Edwin I. Hatch Nuclear Plant  
Request to Revise Technical Specifications:  
Pressure and Temperature Limits

Page Change Instructions

Attachment 1 to Enclosure 3

Marked-Up Pages

Figure 3.4.9-1 (page 1 of 1)  
Pressure/Temperature Limits for  
Inservice Hydrostatic and Inservice Leakage Tests

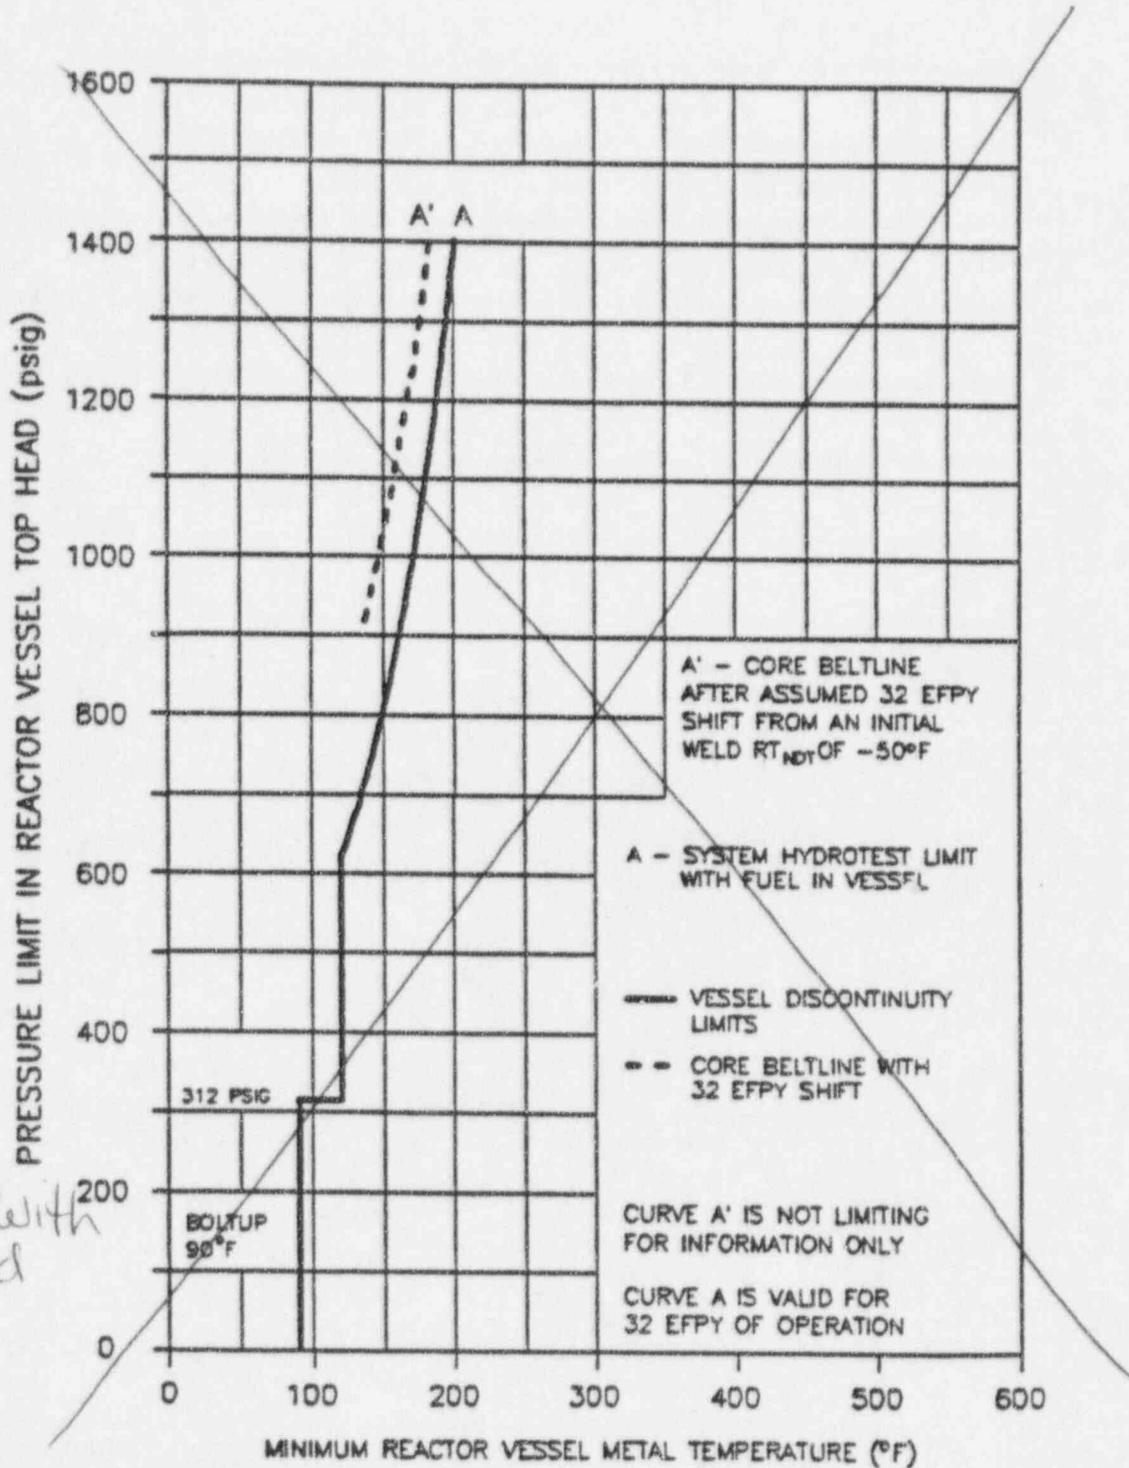
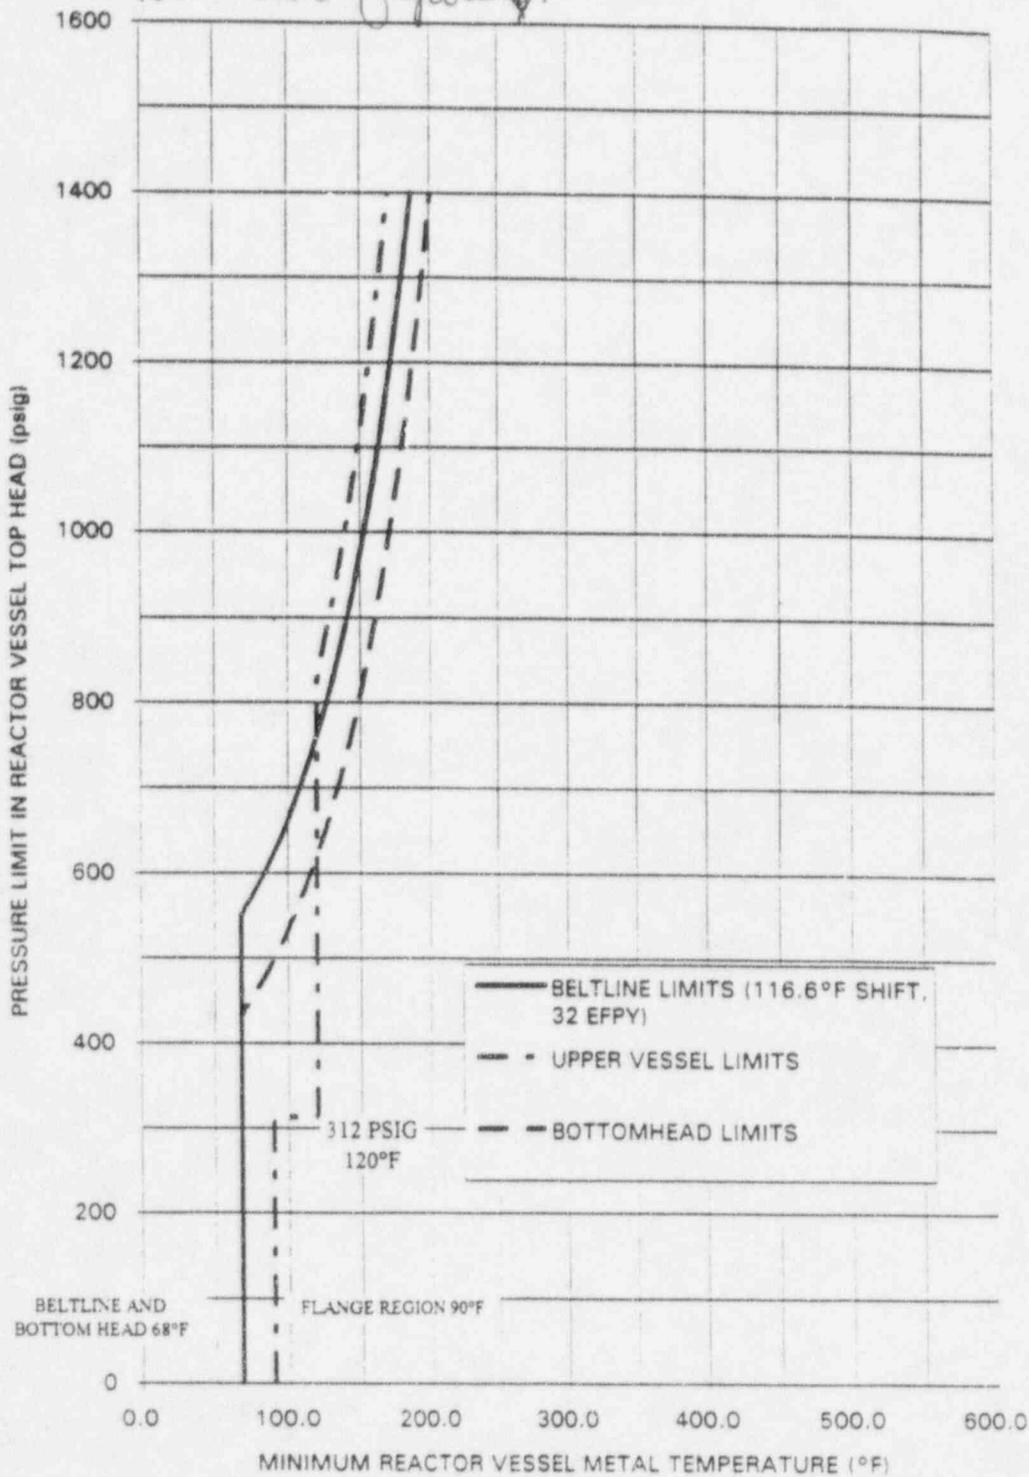
Replace with attached figure.

Replace current Figure 3.4.9-1  
with this figure.

Figure 3.4.9-2 (page 1 of 1)  
Pressure/Temperature Limits for Non-Nuclear Heatup,  
Low Power Physics Tests, and Cooldown Following a Shutdown

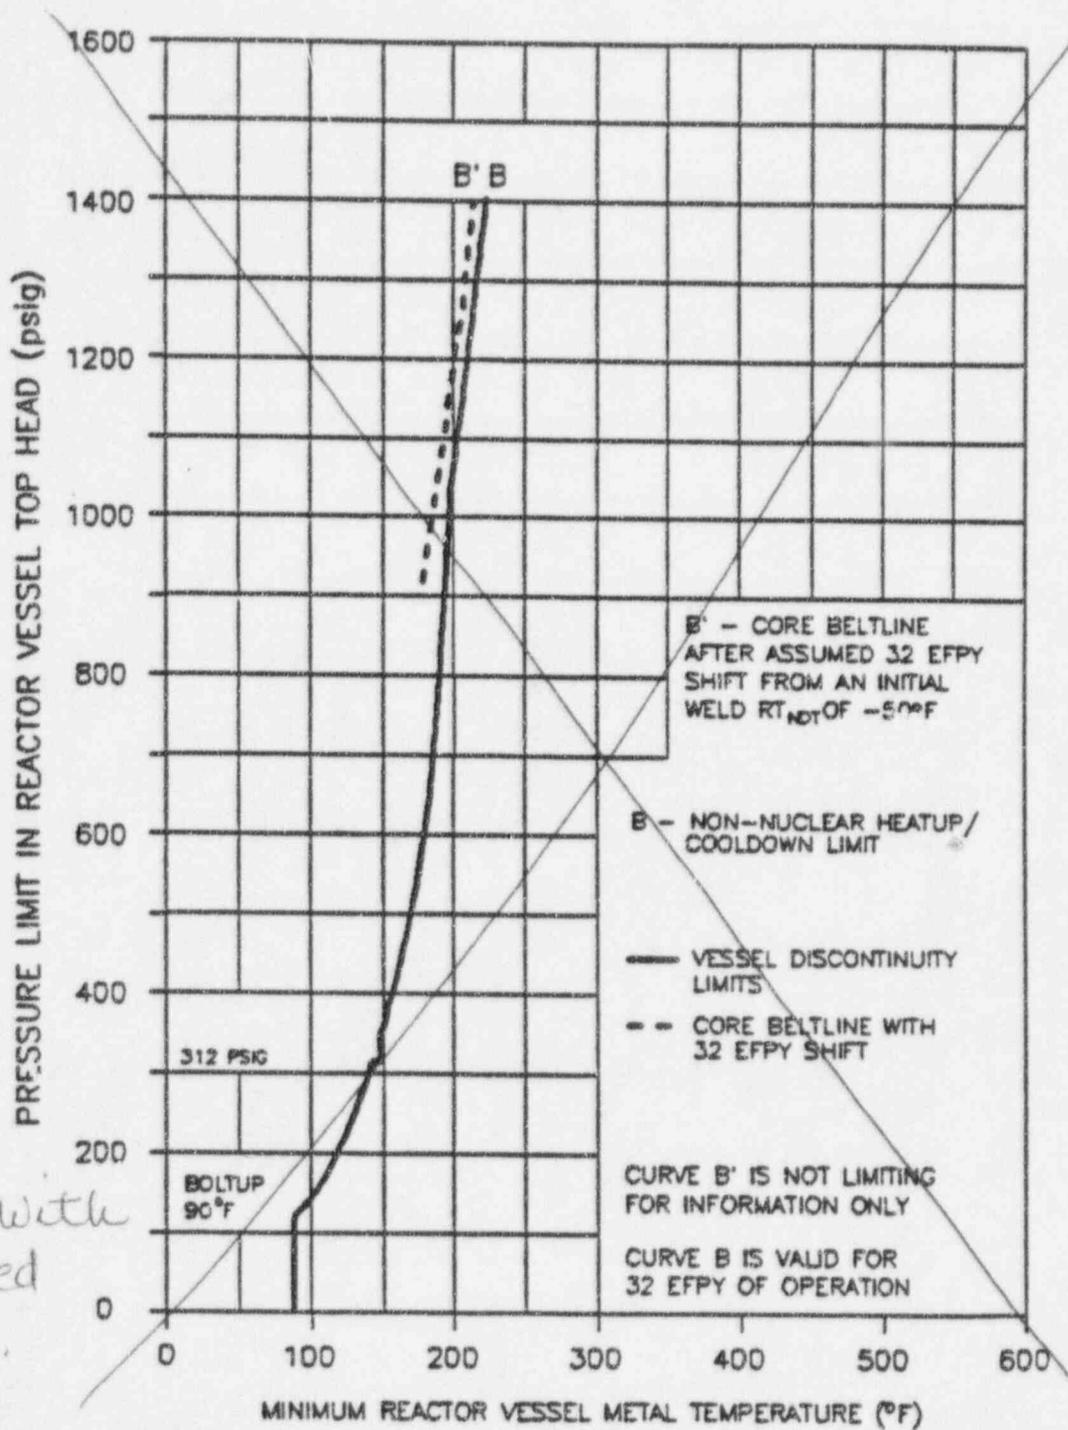
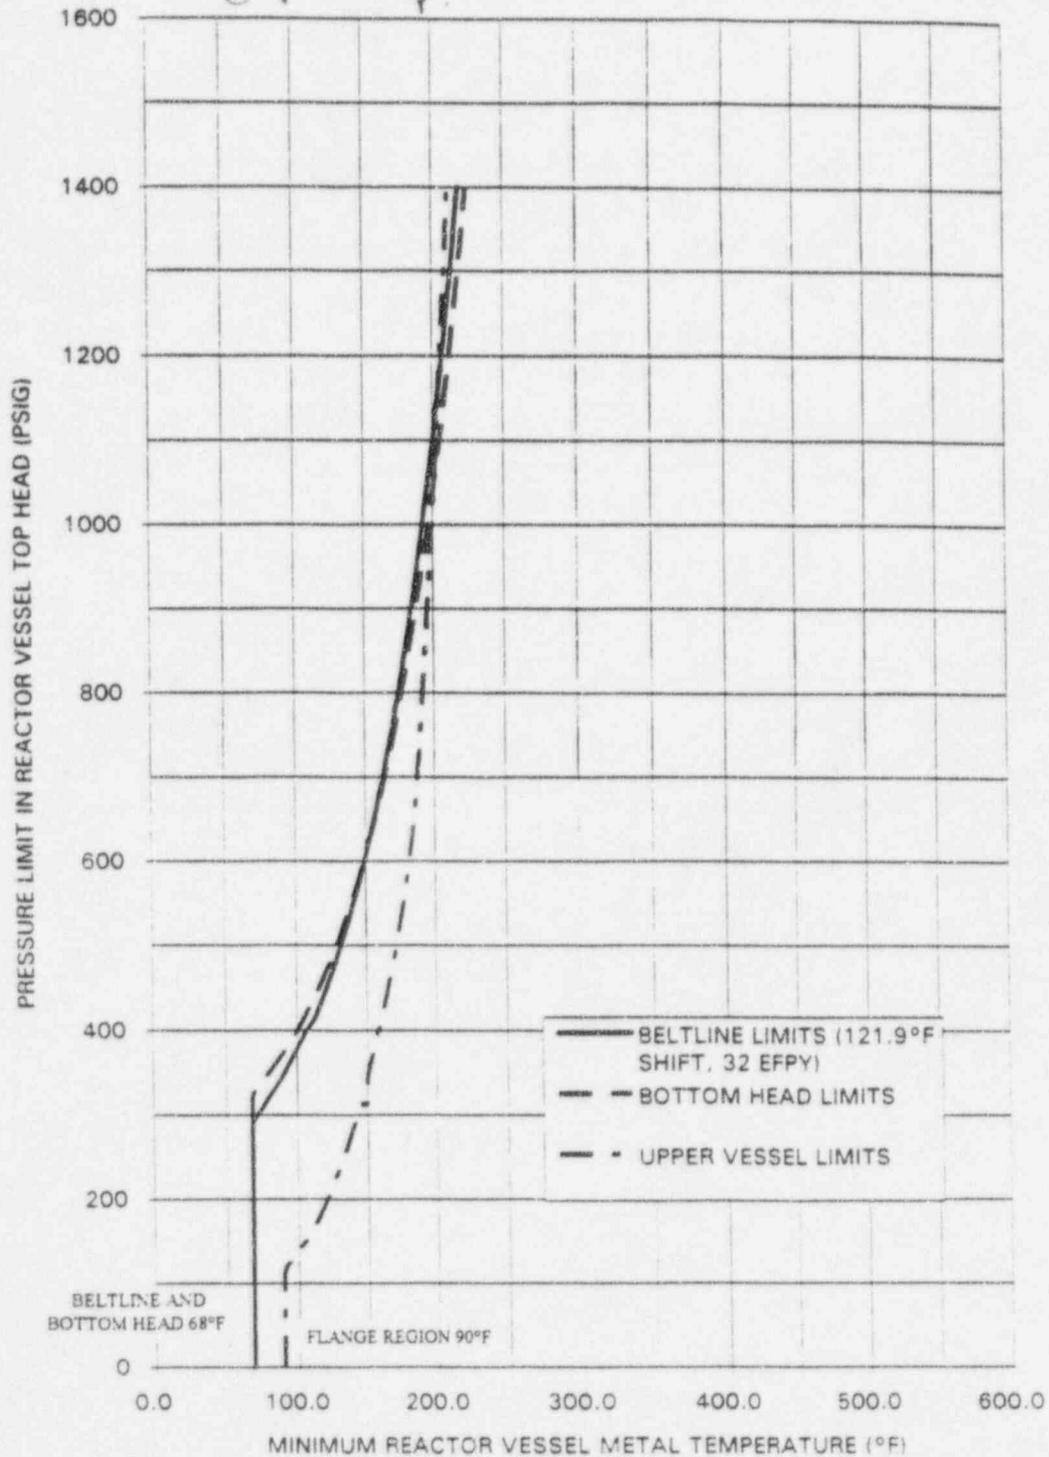
Replace with  
attached  
figure.

Replace current 3.4.9-2 with  
this figure ↓

Figure 3.4.9-3 (page 1 of 1)  
Pressure/Temperature Limits for Criticality

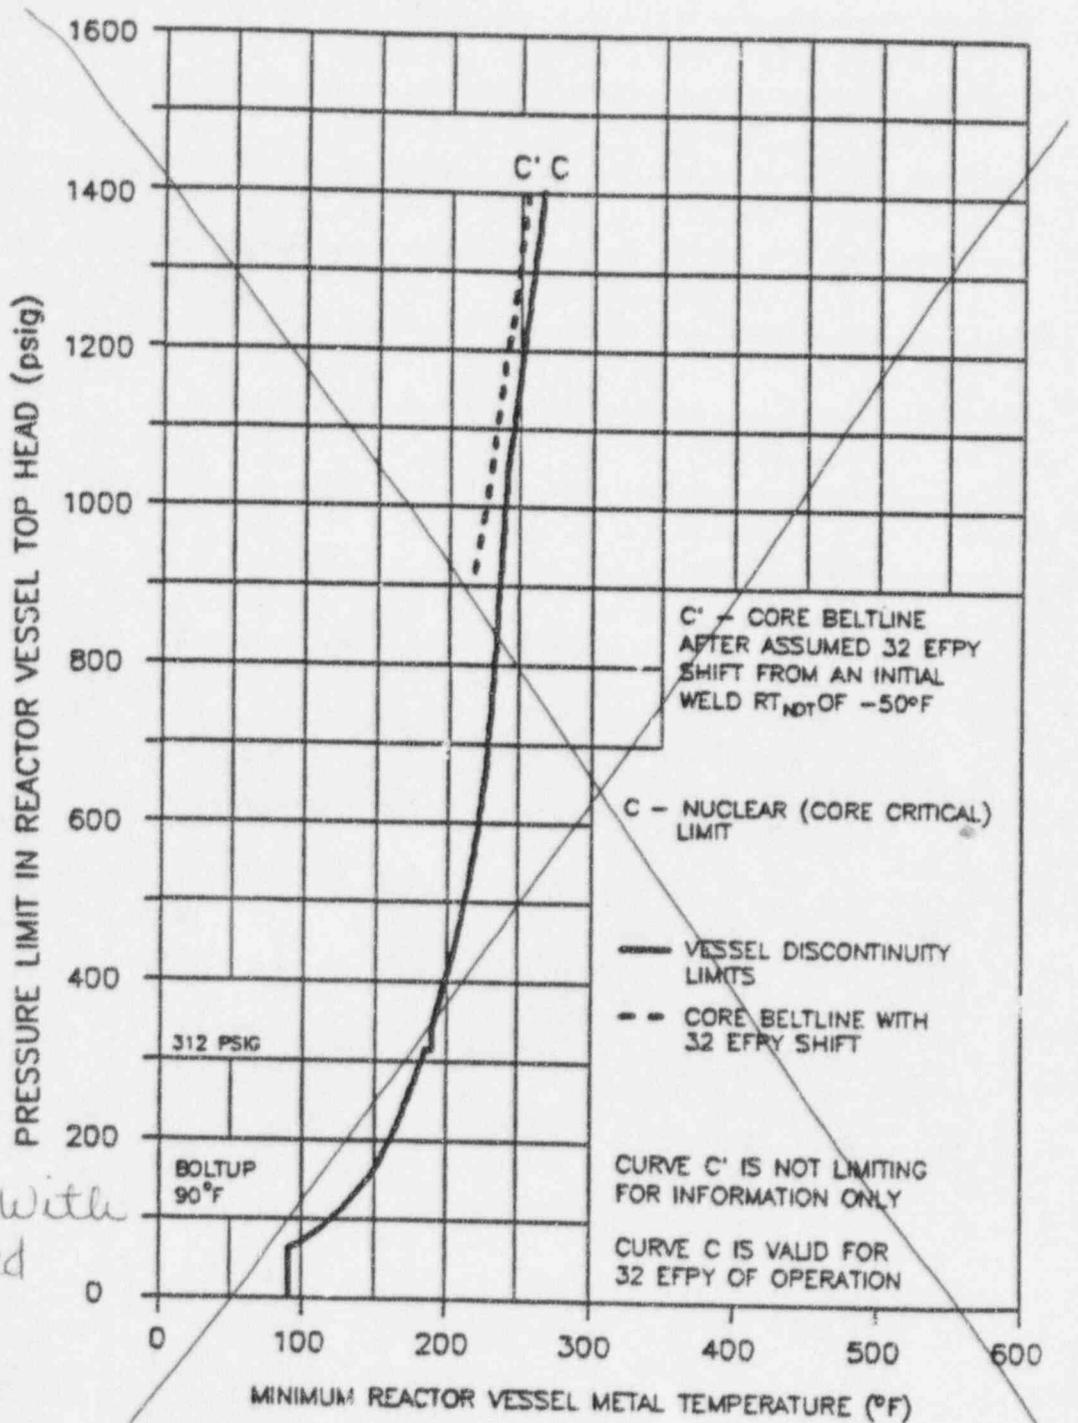
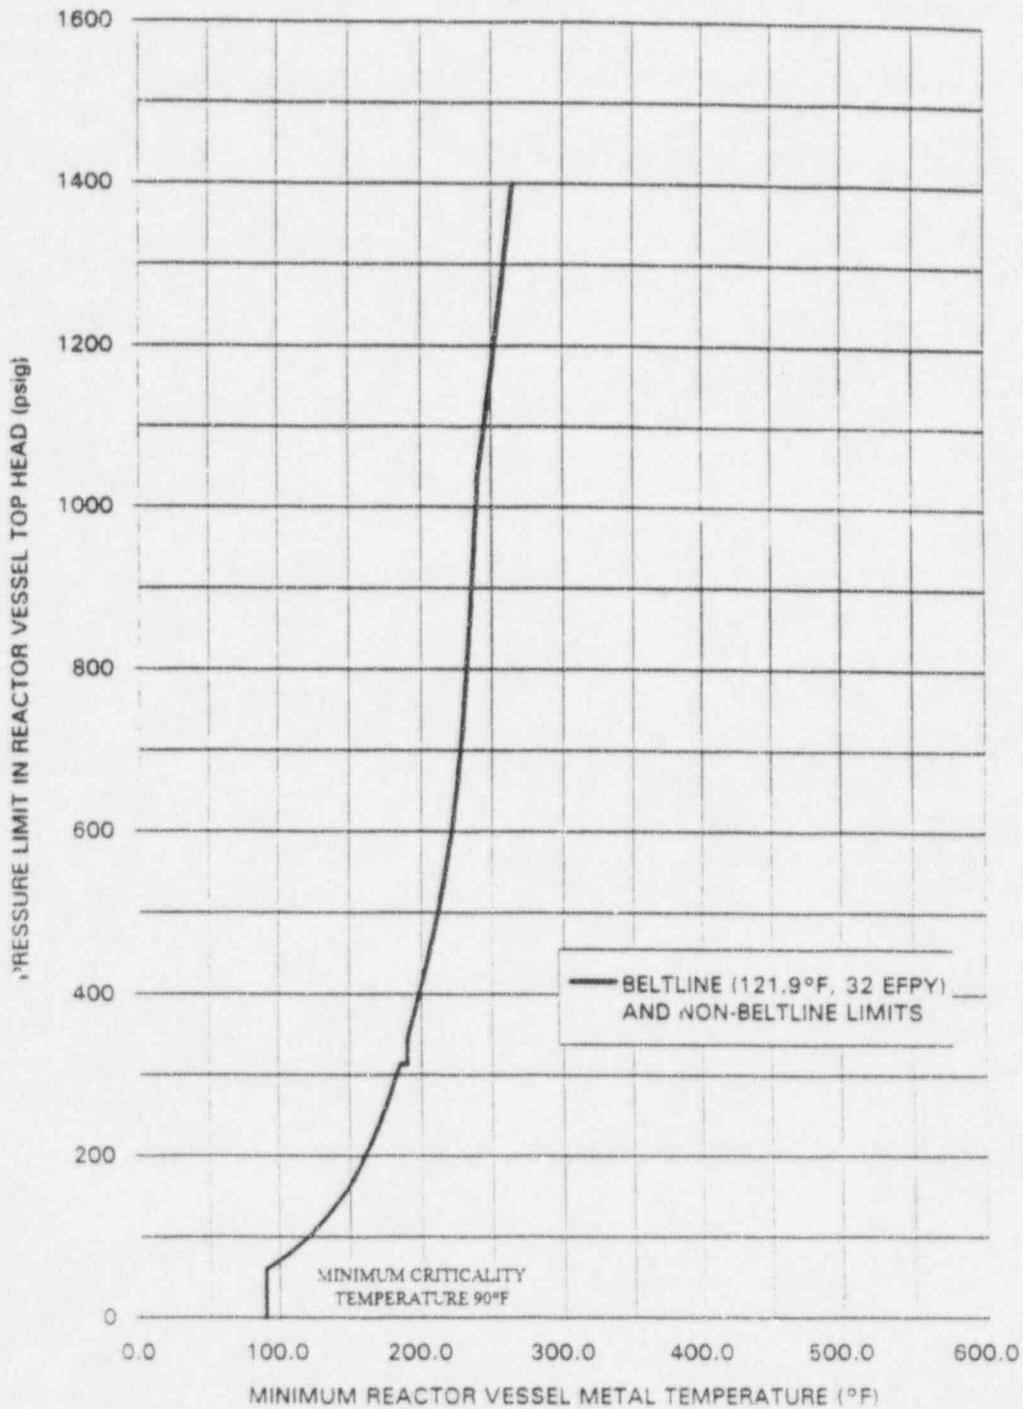
Replace with  
attached  
figure.

Replace current Figure 3.4.9-3  
with this figure.
